ULNRC- 05206

**DOCKET NUMBER 50-483
CALLAWAY PLANT
UNION ELECTRIC COMPANY
LICENSE AMENDMENT REQUEST OL 1258
REVISION TO TECHNICAL SPECIFICATION 3.7.3,
"MAIN FEEDWATER ISOLATION VALVES (MFIVs)"**

**LICENSE AMENDMENT REQUEST OL 1258
REVISION TO TECHNICAL SPECIFICATION 3.7.3,
"MAIN FEEDWATER ISOLATION VALVES (MFIVs)"**

Figure 3.7.3-1 (Page 1 of 1)
 MFIV Stroke Time Limit vs Steam Generator Pressure
 3.7-8a

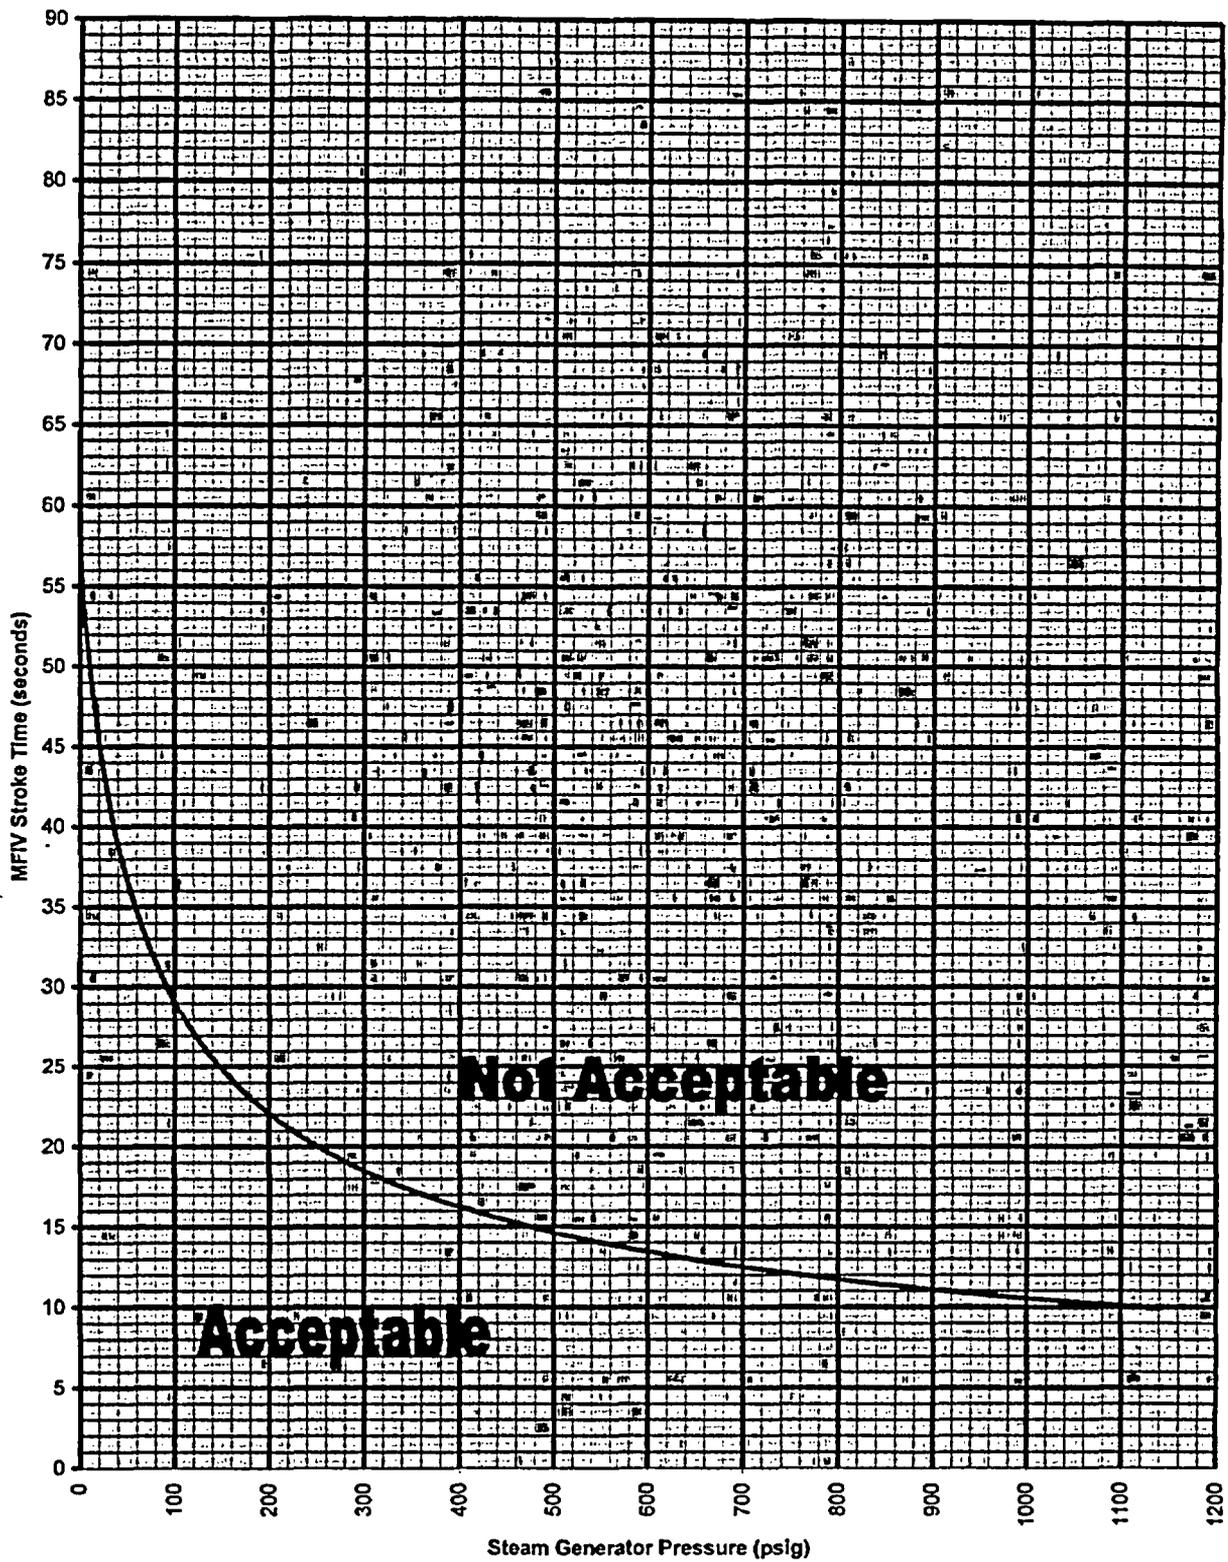
Proposed new SR 3.7.3.3 would specify a stroke-time test requirement more appropriate to the MFIV system-medium actuator design and its associated system-pressure dependent stroke time. Specifically, the statement of proposed SR 3.7.3.3 requires verifying that the closure time for each MFIV is within the limits of Figure 3.7.3-1, which is a new figure that is being added to TS 3.7.3. Figure 3.7.3-1 is a curve of the MFIV isolation time limit as a function of steam generator pressure, in lieu of a single-valued stroke time limit as currently specified. The frequency for performing this surveillance, i.e., for verifying that the MFIV isolation (closure) time is within the limits of Figure 3.7.3-1, would continue to be in accordance with the Inservice Testing Program.

AmerenUE is proposing a revised Technical Specification that will capture the dependency on steam generator pressure of the MFIV stroke time. The proposed TS change provides the requirement that the closure time for each MFIV is within the limits of Figure 3.7.3-1. Figure 3.7.3-1 is a curve of the MFIV isolation time limit as a function of steam generator pressure and provides a variable stroke time for the MFIVs. Having a stroke time limit requirement that is dependent on steam generator pressure enables performance of the required MFIV surveillance at any particular operating condition bounded by the curve.

After receipt of the amendment requested per this application, implementation of the amendment will make Figure 3.7.3-1 effective as the acceptance criterion for the MFIV stroke time test(s) required per SR 3.7.3.3. Proposed Figure 3.7.3-1 is a bounding curve that provides the required MFIV stroke time limit as a function of secondary system pressure. As described in Section 3.0, proposed Figure 3.7.3-1 is based on a performance curve that was established for the MFIVs and validated, in part, by field testing of the valves at various pressures.

SR 3.7.3.3 Verify the closure time of each MFIV is within the limits of Figure 3.7.3-1.	In accordance with the Inservice Testing Program
---	---
